## **CALIFORNIA REGIONAL WATER QUALITY CONTROL BOARD - SAN DIEGO REGION** WATERSHED MANAGEMENT PROGRAM

### FACILITY INSPECTION REPORT

FACILITY: 501, 505 1<sup>st</sup> Street, Coronado 401 File #: 05C-041 **INSPECTION DATE/Time: 6/12/06**

## FACILITY: 501 & 505 1st Street, Coronado, CA 92118

Figure 1. Pre-Construction condition of shoreline (photo provided by the SD Port District)

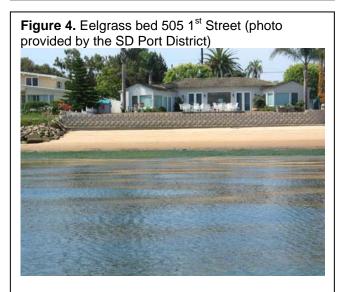
- II. FINDINGS (See attached photos)
- 401 certification (File No. 05C-041) issued to Bill & Heidi Dickerson was for riprap replacement along 80 linear feet of shoreline in front of the property. The project as proposed would have removed 450 cy of existing riprap (see Figure 1) and replaced it with filter fabric and quarry riprap. The project as put forth in the 401 application would have been similar to the adjacent City of Coronado shoreline stabilization project. (See Figure No. 5). The 401 cert. Did not authorize the construction of a seawall or the deposition of sand into the Bay to form a beach.

Figure 2. Post construction shoreline condition, with un-permitted seawall construction, and discharge of fill material (beach sand)

- A Cleanup and Abatement Order is recommended requiring the removal of the seawall and artificial Beach, and direct the responsible parties to construct the project as permitted. A study needs to be done to determine if eelgrass has been impacted, and if this is the case, mitigation should be provided consistent with the Southern California Eelgrass Mitigation policy.
- Coordination should be sought with the Port District and Army Corps for any enforcement action to assure regulatory consistency.
- •
